PENNSYLVANIA ELECTRIC COMPANY
THREE MILE ISLAND NUCLEAR STATION UNIT 1

Operating License No. DPR-50
Docket No. 50-289
Technical Specification Change Request No. 36
Amendment 1

Technical Specification Change Request No. 36, Amendment 1

4.16 REACTOR INTERNALS VENT VALVES SURVEILLANCE

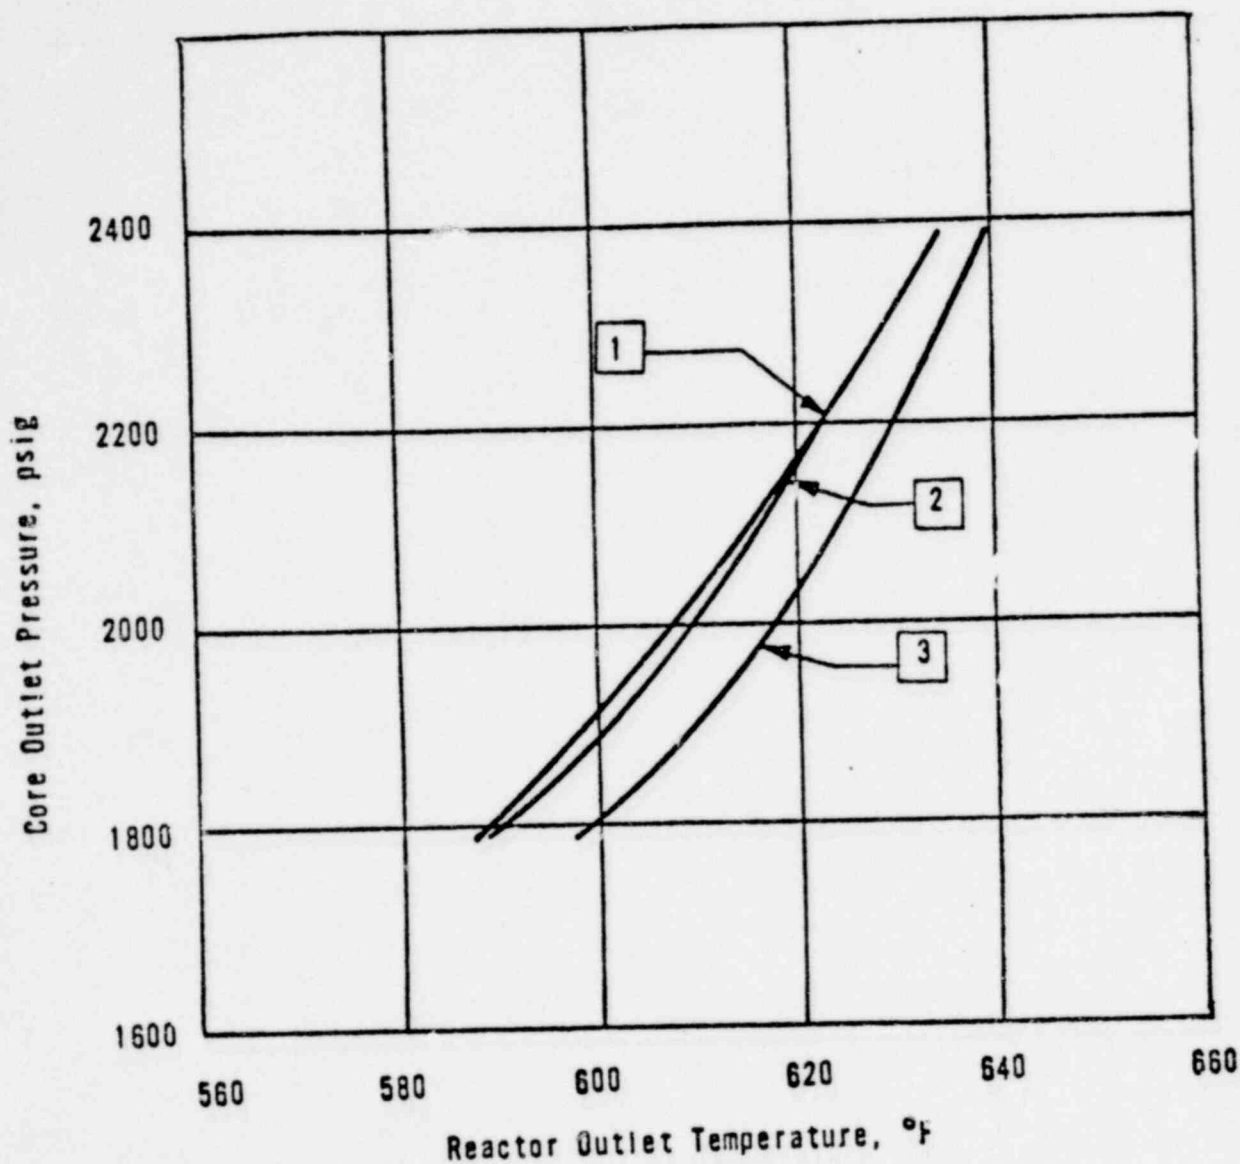
- 4.16.1 At intervals not exceeding the refueling interval, each reactor internals vent valve will be tested to verify that no valve is stuck in the open position and that each valve continues to exhibit freedom of movement.

Verifying vent valve freedom of movement insures that coolant flow does not bypass the core through reactor internals vent valves during operation and therefore insures the conservatism of Core Protection Safety limits as delineated in figures 2.1-1 and 2.1-3, and the flux/flow trip setpoint.
